TO: Mercedes-Benz Dealer Principals, General Managers, Sales Managers, Service Managers, Parts Managers	FROM: Gregory Gunther, Department Manager, Vehicle Compliance and Analysis, Engineering Services
RE: Emission Service Campaign 2021070021 Launch Notification Replace Vehicle Emission Control Information Label MY21 (S-Class)	DATE: August, 20 2021

Service Campaign Bulletin

Campaign No. 2021070021, August 2021

Replace Vehicle Emissions Control Information Label

Figure 1

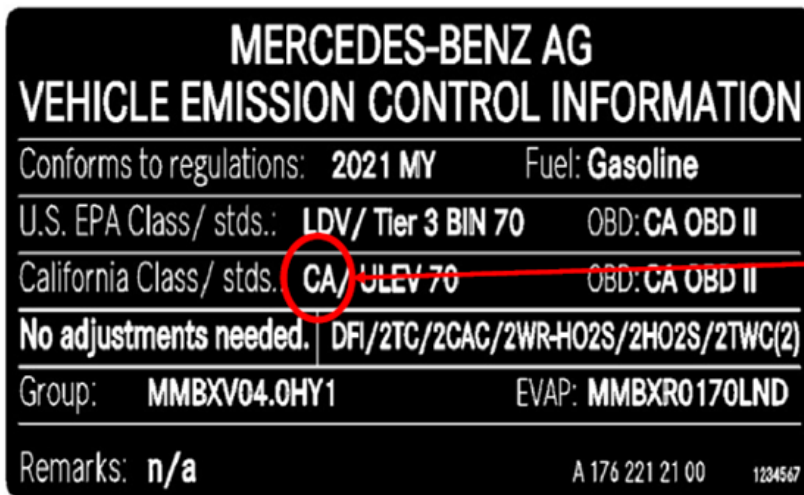
1. Open hood.
2. Replace vehicle emissions control information label (**Figure 1**) on hood.
 - i** The new information label must include the text "**PC**" instead of "**CA**" (**Figure 2**).
 - i** For model 223 – bonding position 3.4. see (**Figure 3**).
 - i** Use a hot air gun to remove the old information label.
 - i** Perform a thorough cleaning to remove contamination and adhesive residues from the old information label.
